Modifications to Accor Sofitel Hotel Site 4A, Olympic Boulevard Sydney Olympic Park

SECTION 75W APPLICATION

Date: 17 January 2007

<u>A-2001</u>	<u>G</u>	<u>Changes to EA Approved Façade – North Elevation</u>	<u>21.12.06</u>
<u>A-2002</u>	<u>G</u>	<u>Changes to EA Approved Façade – South Elevation</u>	<u>21.12.06</u>
<u>A-2003</u>	<u>G</u>	<u>Changes to EA Approved Façade – East Elevation</u>	<u>21.12.06</u>
<u>A-2004</u>	<u>E</u>	<u>Changes to EA Approved Façade – West Elevation</u>	<u>21.12.06</u>

Project
SO F I T E L
SYDNEY OLYMPIC PARK
OLYMPIC BOULEVARD HOMEBSH
CHANGES TO EA-APPROVED FACADE
WEST ELEVATION

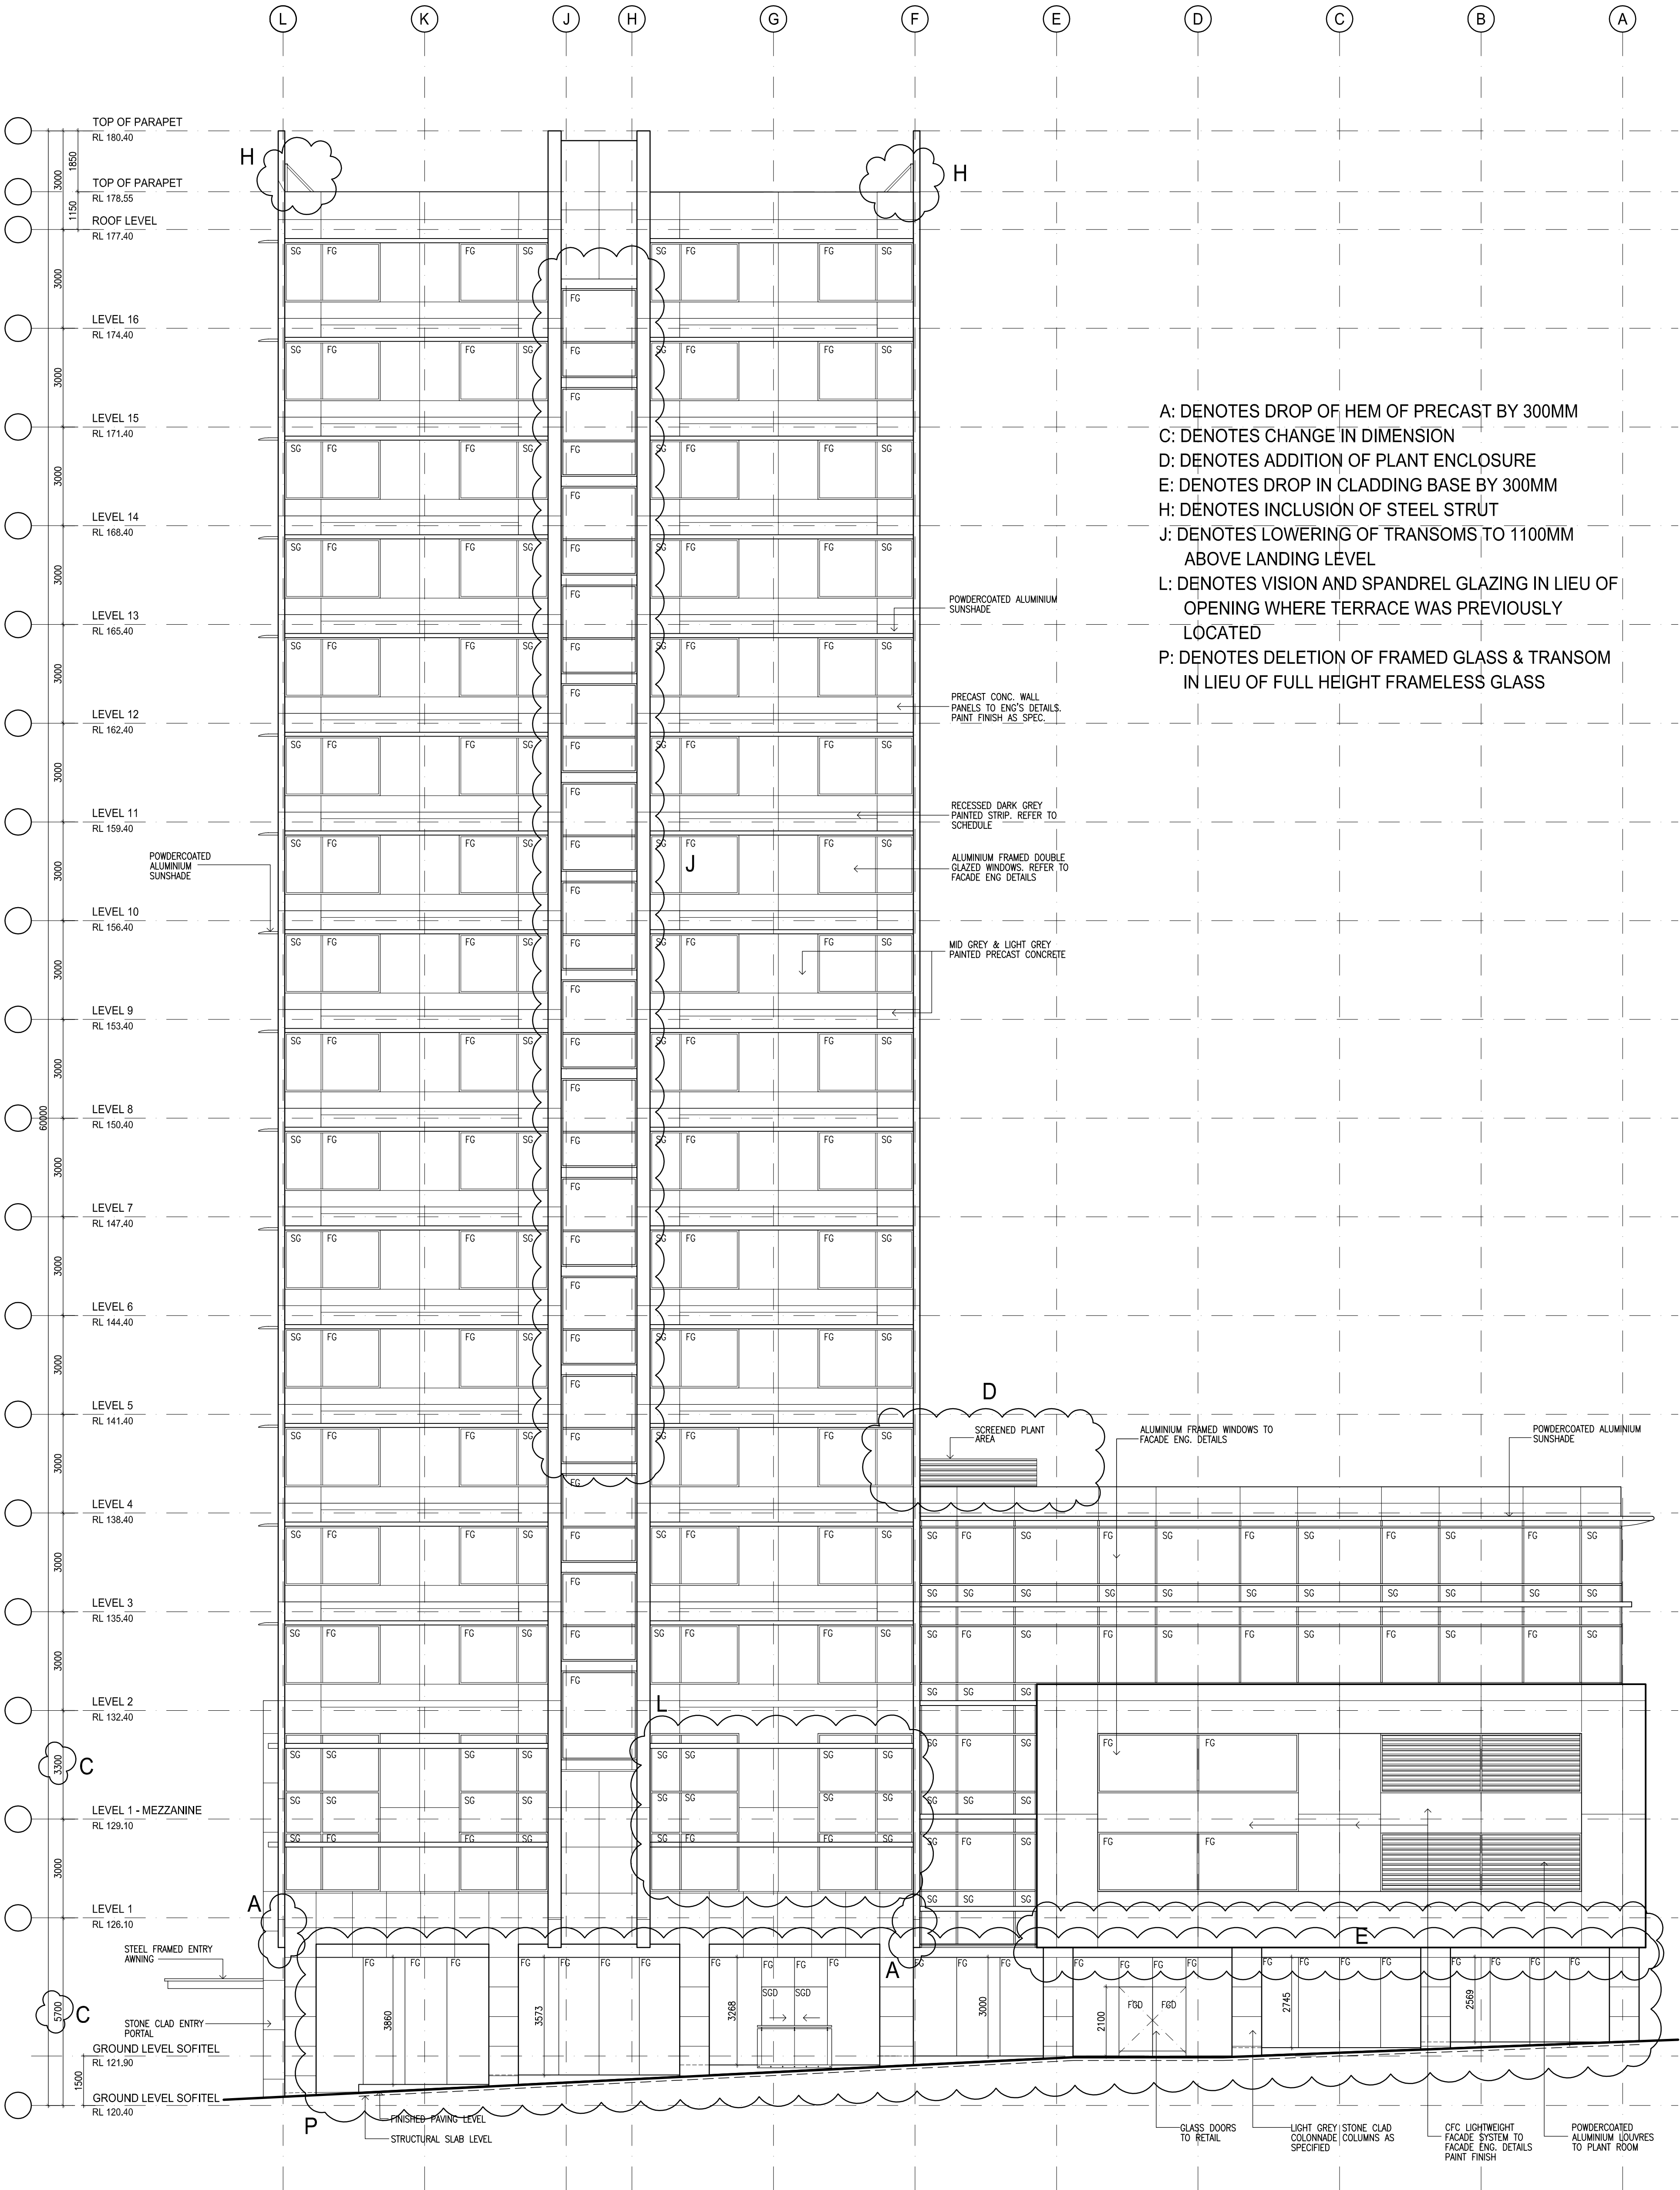
- A: DENOTES DROP OF HEM OF PRECAST BY 300MM
- C: DENOTES CHANGE IN DIMENSION
- D: DENOTES ADDITION OF PLANT ENCLOSURE
- E: DENOTES DROP IN CLADDING BASE BY 300MM
- H: DENOTES INCLUSION OF STEEL STRUT
- J: DENOTES LOWERING OF TRANSOMS TO 1100MM ABOVE LANDING LEVEL
- L: DENOTES VISION AND SPANDREL GLAZING IN LIEU OF OPENING WHERE TERRACE WAS PREVIOUSLY LOCATED
- P: DENOTES DELETION OF FRAMED GLASS & TRANSOM IN LIEU OF FULL HEIGHT FRAMELESS GLASS
